Impedance impact of material of HL-LHC Y chambers

Impedance impact of removing copper layer

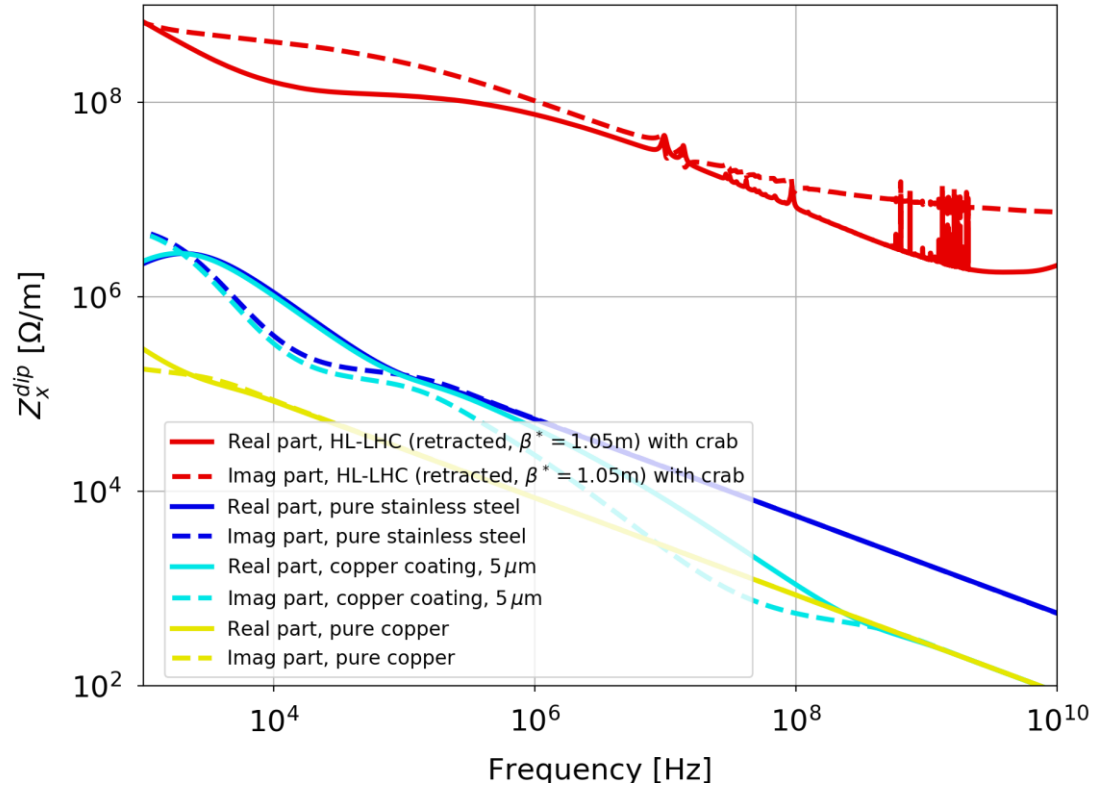
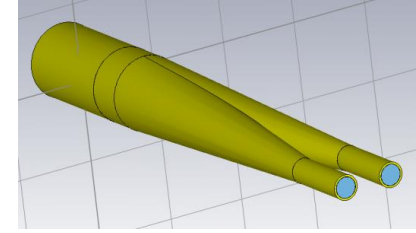
Replacing bulk copper by bulk stainless steel:

- Increase by a factor 6 to 7 of both transverse and longitudinal impedance over the frequency range of interest
- Clear benefit from impedance point of view of using copper

Using a thin copper layer:

- The factor 6 to 7 with respect to bulk stainless steel is maintained at high frequencies
 - $f > 100$ MHz for 5 microns layer
 - $f > 10$ MHz for 20 microns layer
- Lower factor at lower frequencies

HL-LHC optics v1.5

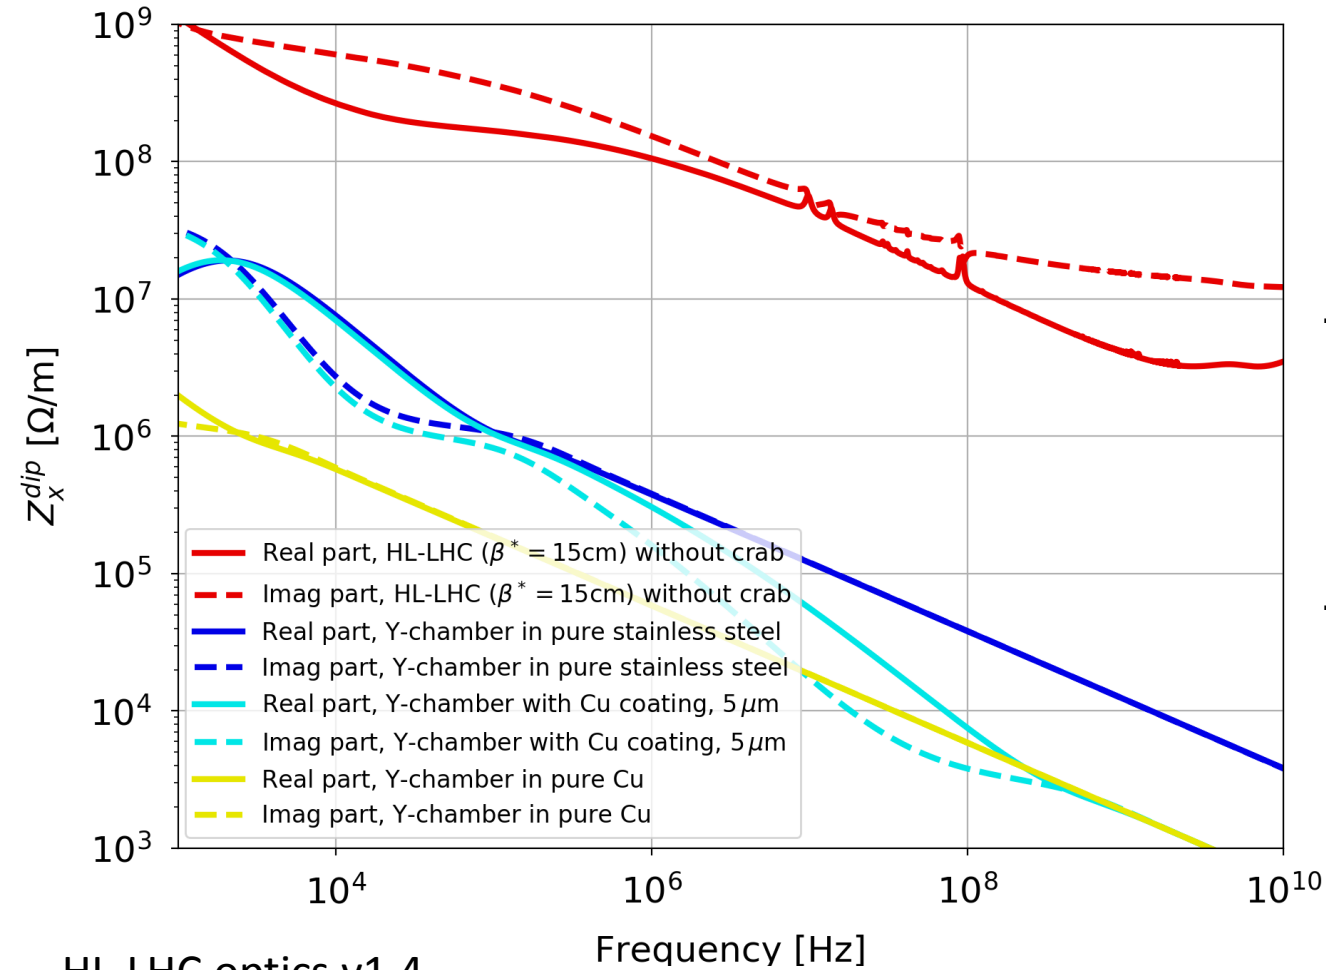
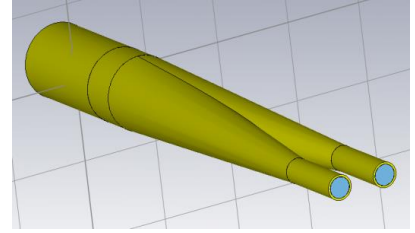
→ As expected, Y chamber contribution very low compared to HL-LHC impedance model for all frequencies at the most critical moment for instabilities (just before collisions)

→ As expected, very low impact on HL-LHC beam stability (tiny length compared to the full LHC)

HL-LHC optics v1.4

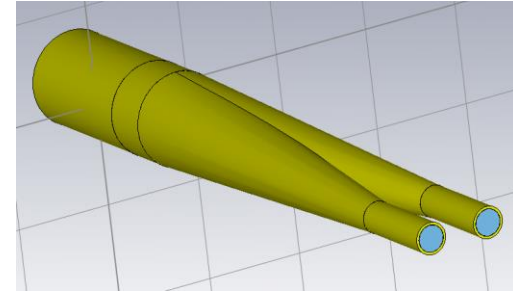
→ Even for the largest β -function at the Y chambers (reached at the very end of levelling), Y chamber contribution remains very low compared to HL-LHC impedance model

→ As expected, very low impact on HL-LHC beam stability
